METROPOLITAN GOVERNMENT OF NASHVILLE AND DAVIDSON COUNTY

STAFF RECOMMENDATION
305 Scott Avenue
April 15, 2015

Application: New construction-infill
District: Eastwood Neighborhood Conservation Zoning Overlay
Council District: 06
Map and Parcel Number: 083020E90000CO
Applicant: John Root, architect
Project Lead: Paul Hoffman, paul.hoffman@nashville.gov

Description of Project: The Commission approved a two-family building on the site in March. The current project is for a one and one half-story single-family residence.

ARCHITECTURAL SITE PLAN

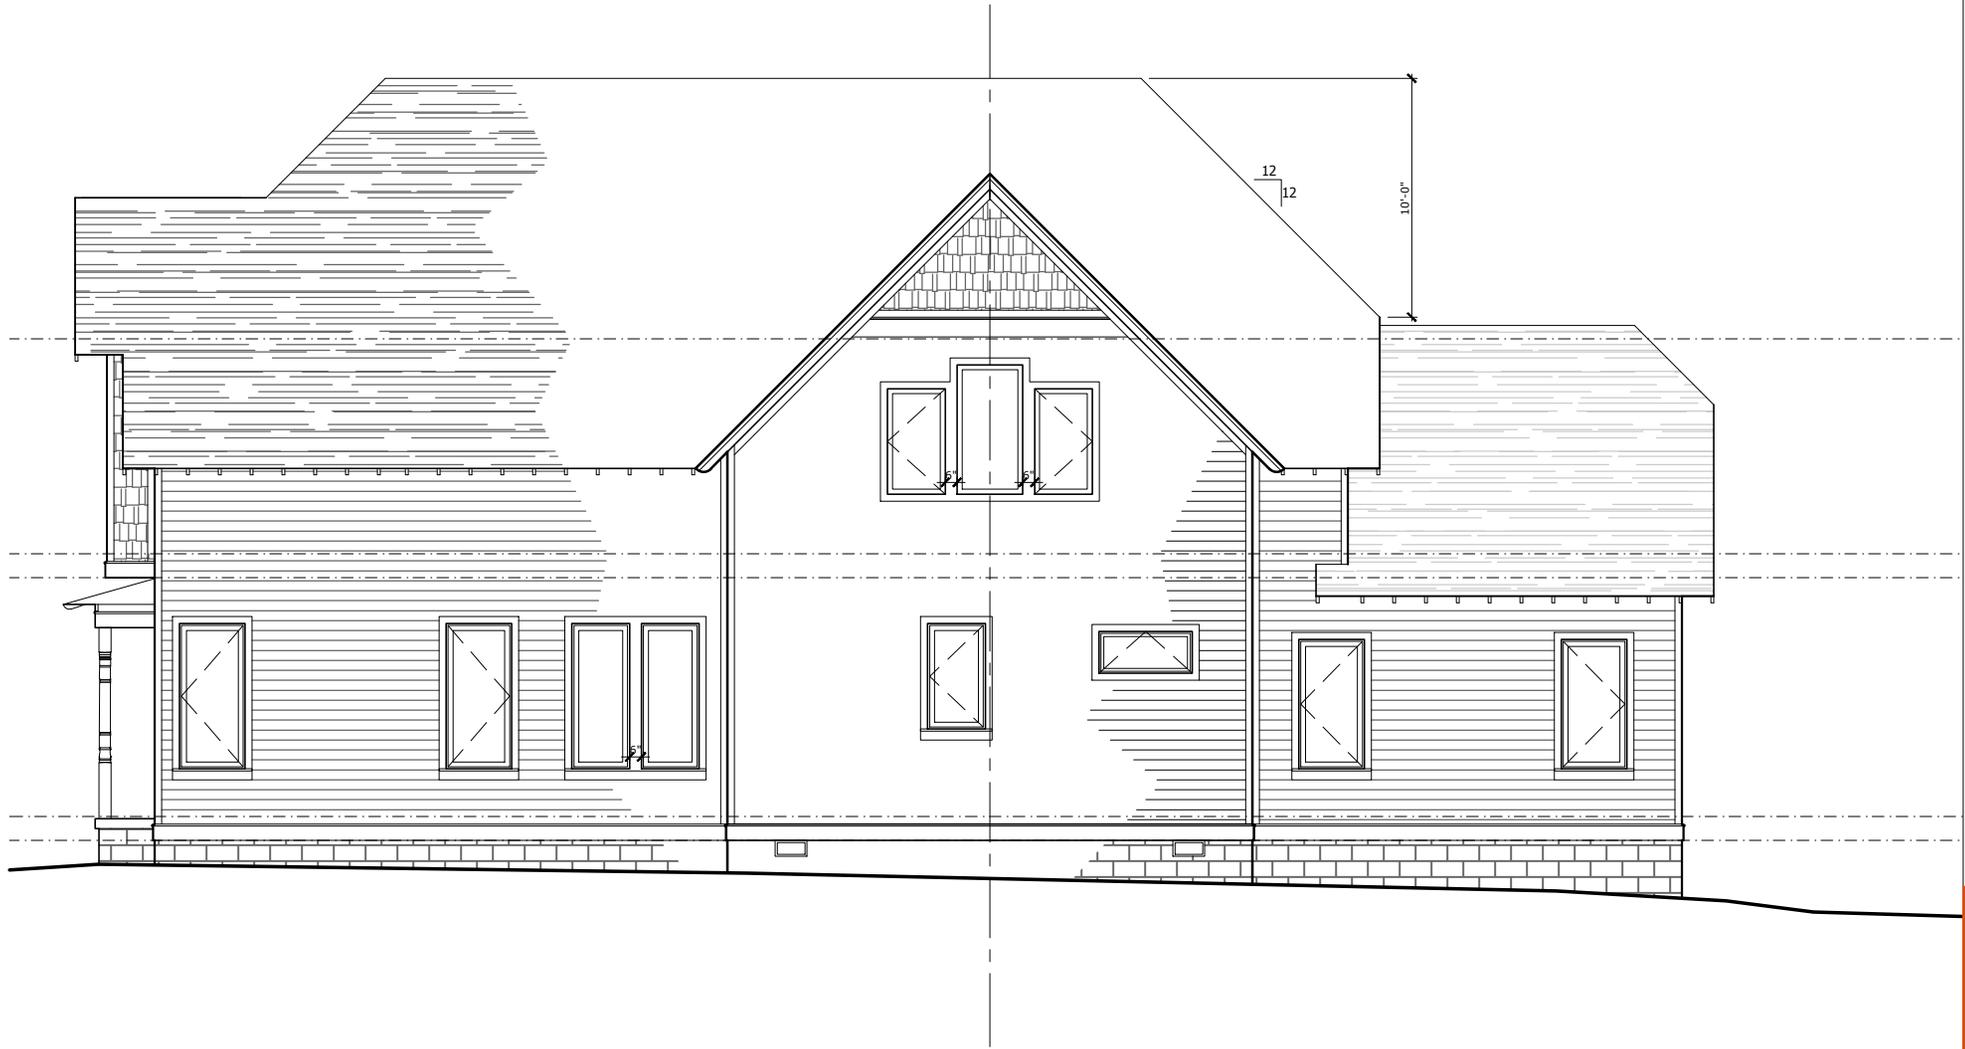
Setback & Rhythm of Spacing: The side setbacks are eleven feet (11') and seventeen feet (17'), which meet the minimum requirement of five feet (5'). The rear setback is approximately one hundred and fourteen feet (114'), more than meeting the required minimum of twenty feet (20'). The site plan submitted does not include the adjacent houses, so Staff was unable to verify the relative front setback of the infill. With the condition that Staff verifies that the front setback is in line with that established by neighboring buildings, the project meets section II.B.1.c.

1. The front setback is in line with that established by adjacent houses;
2. The horizontal window on each side elevation be replaced with a more vertically-proportioned window;

SIDE ELEVATION

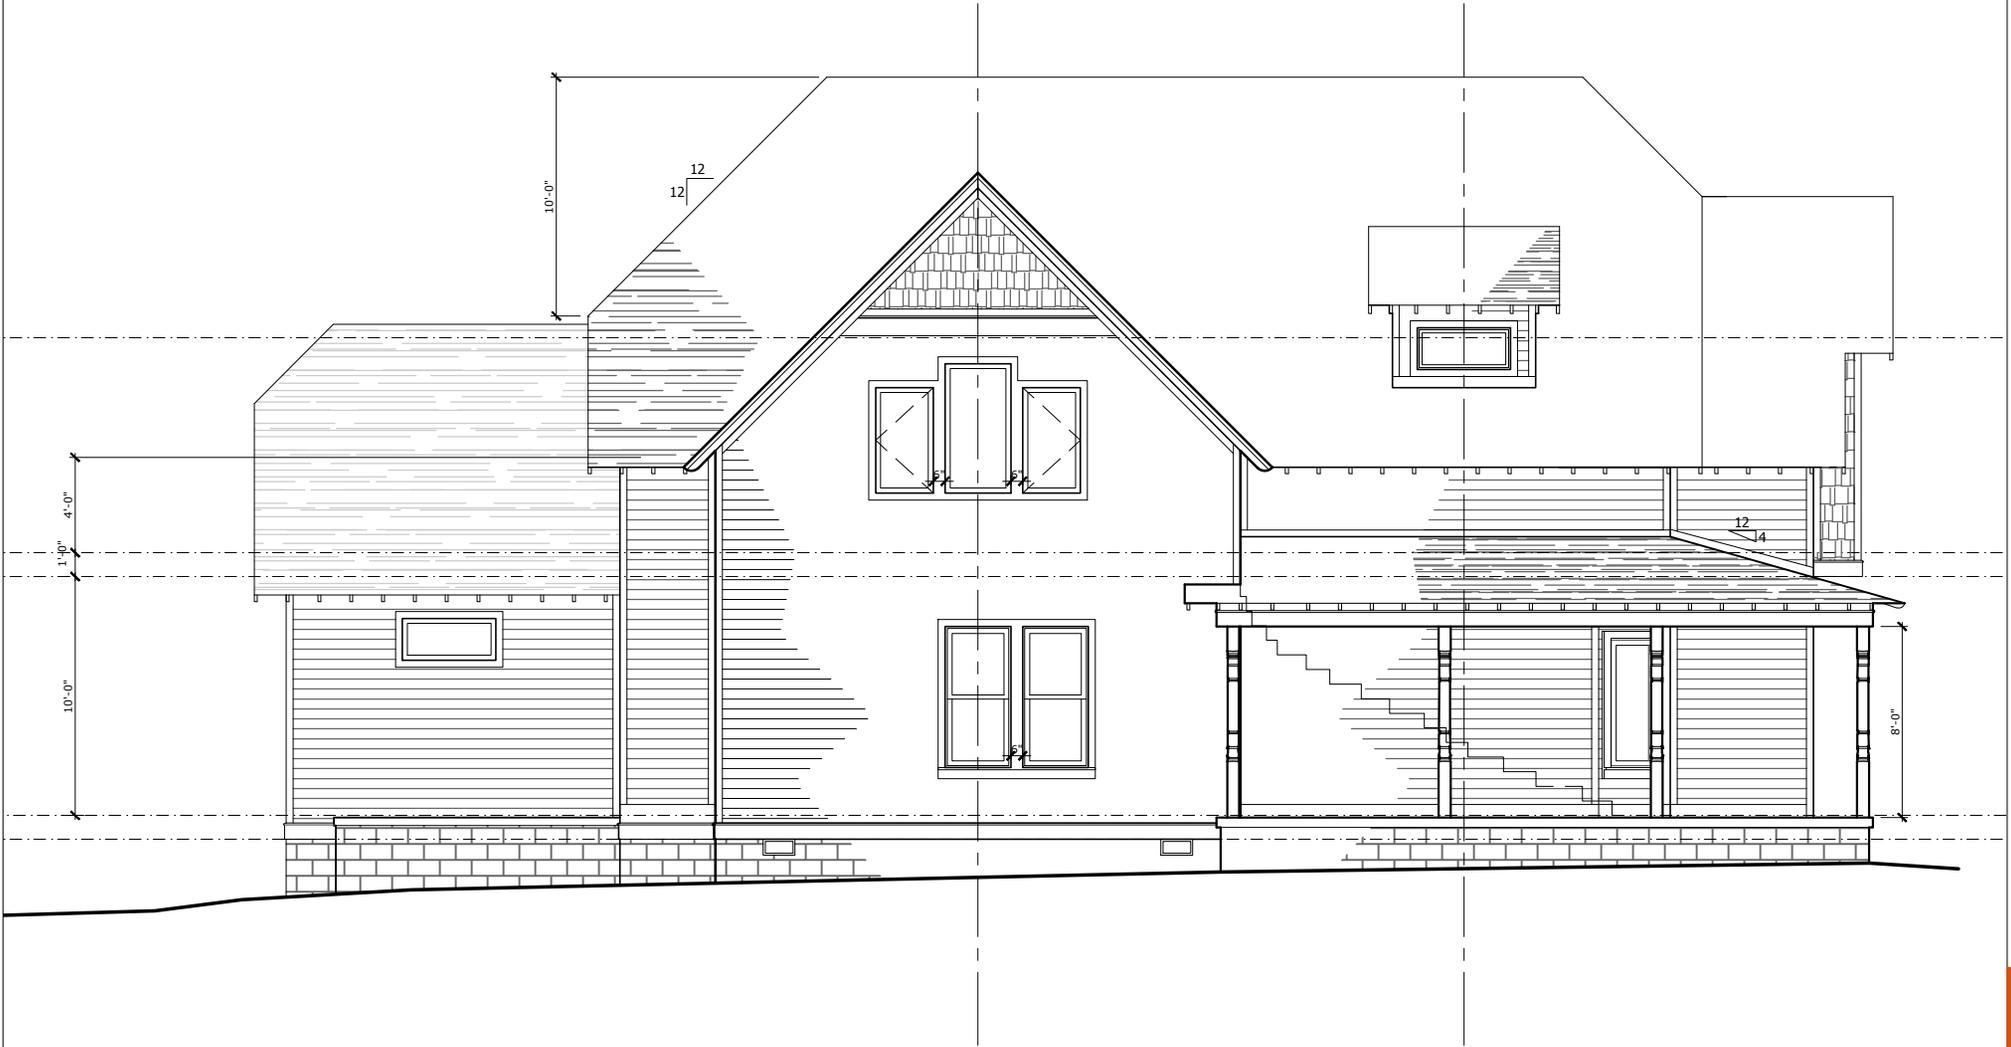
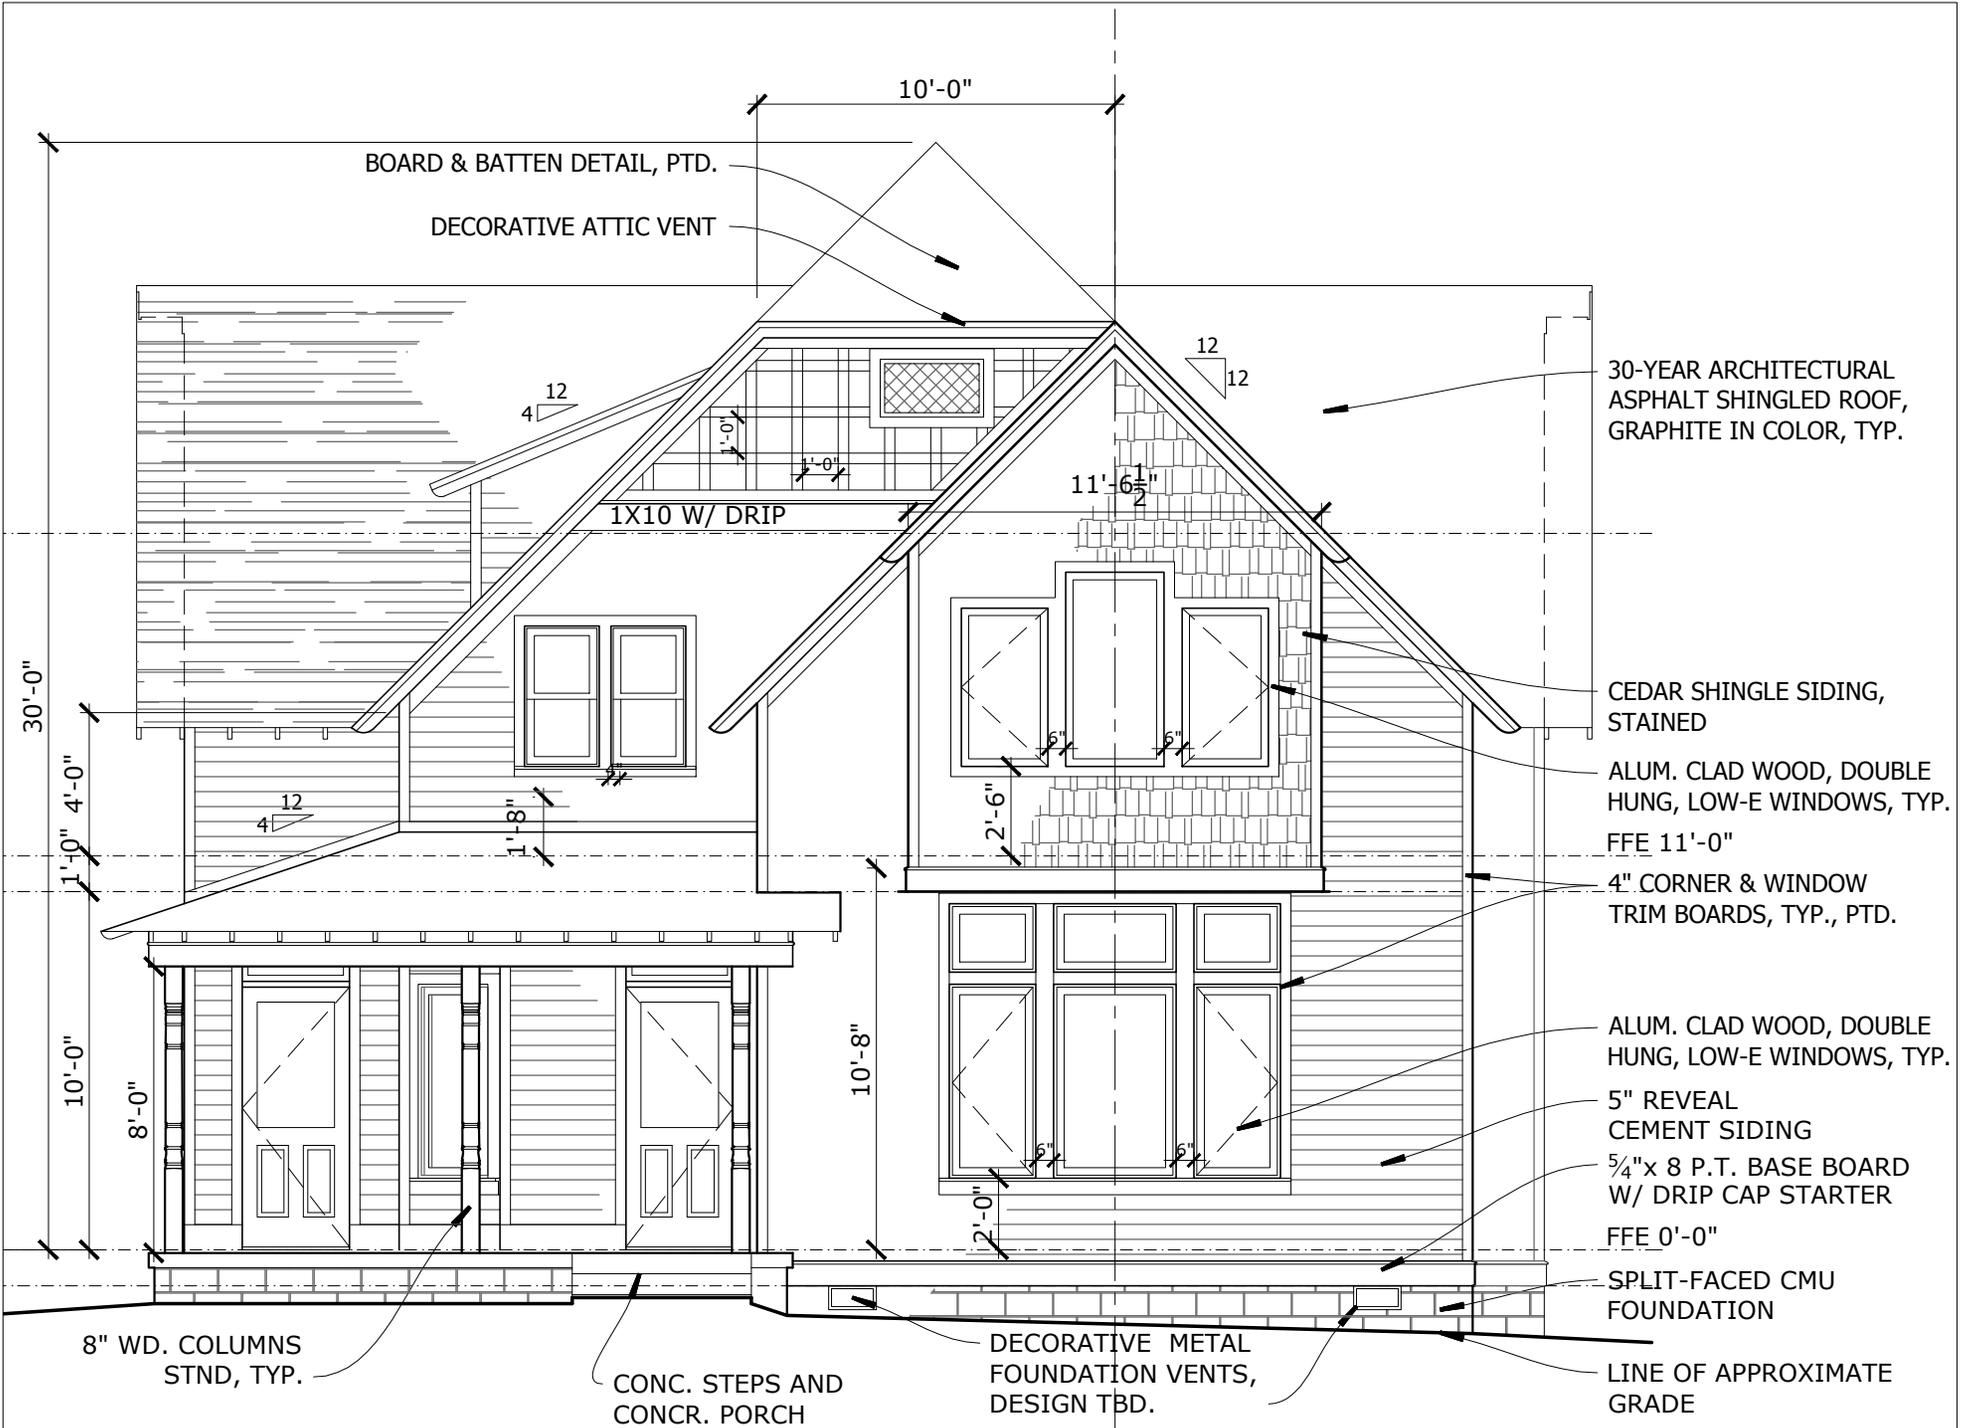
Proportion and Rhythm of Openings: The majority of windows are approximately twice as tall as they are wide. However, each side elevation shows one horizontally-proportioned window that does not meet the historical proportion of windows. Staff requests these windows be replaced by more vertically-proportioned windows. There are no expanses greater than ten feet (10') without an opening. With the condition that the horizontal window on each side is replaced with a more appropriate one, Staff finds the project's proportion and rhythm of openings to meet Section II.B.1.g.
